Addendum # 2

3 Clarifications

REVISION
0
DRAWING No.
W-8

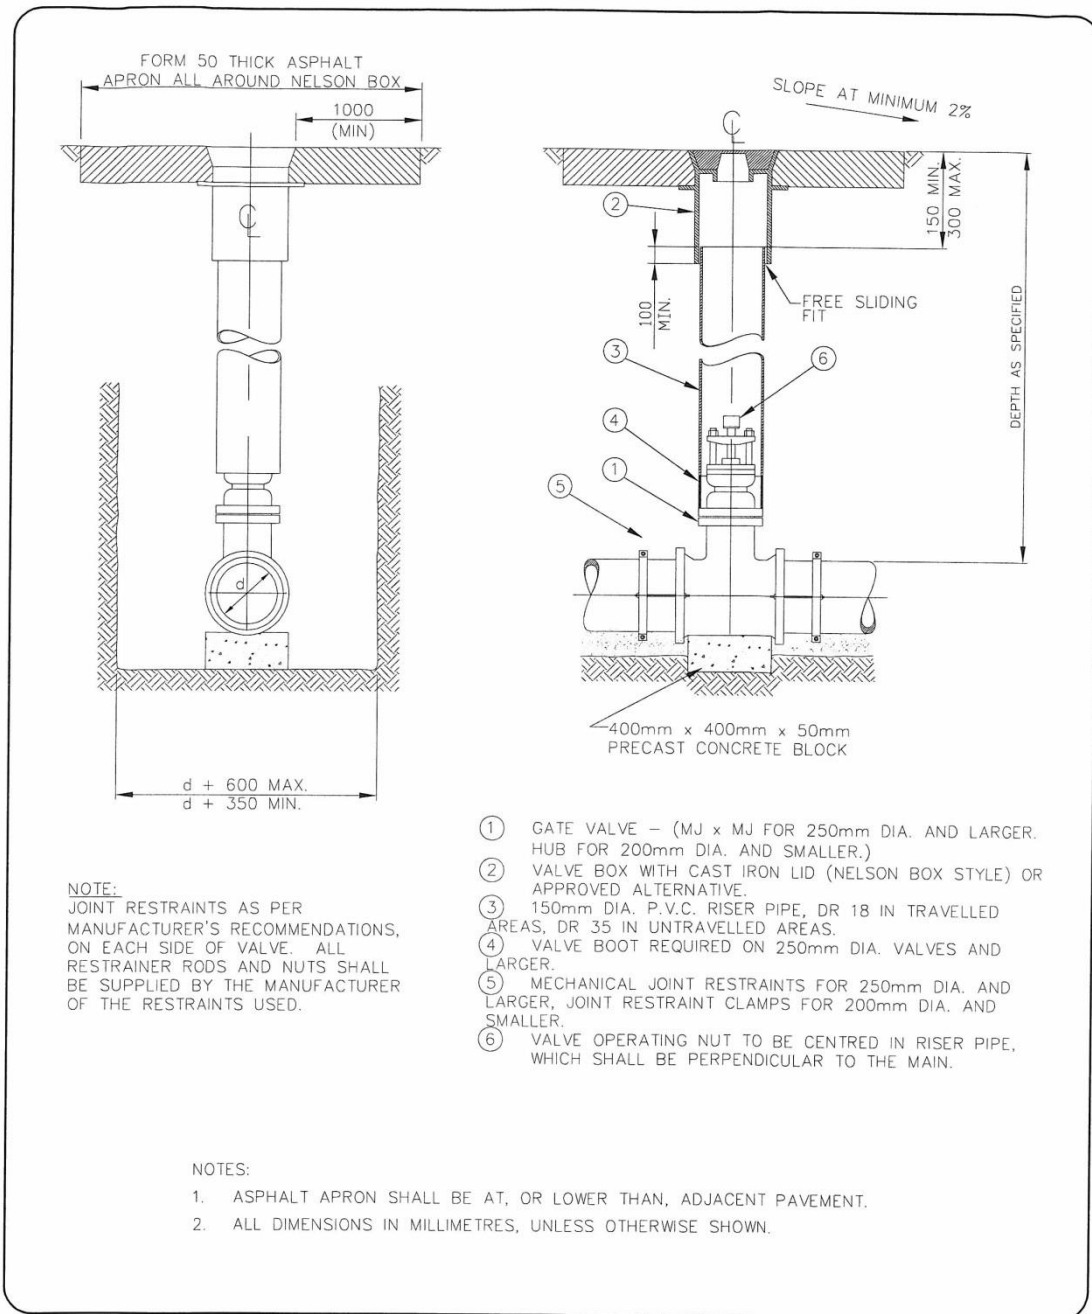
- 3.12 Are air-balance reports required for the HVAC system? - **NO**
- 3.13 RDN detail W-8 specifies MJ Restraints for 250 mm and larger. Please confirm. – **All Hub joints specified for pipe, 250 mm diameter or larger, are to be deleted and replaced with restrained MJ Fittings (EBA Iron Series 2000PV or approved Equal) consistent with RDN Detail W-8, (copy attached)**
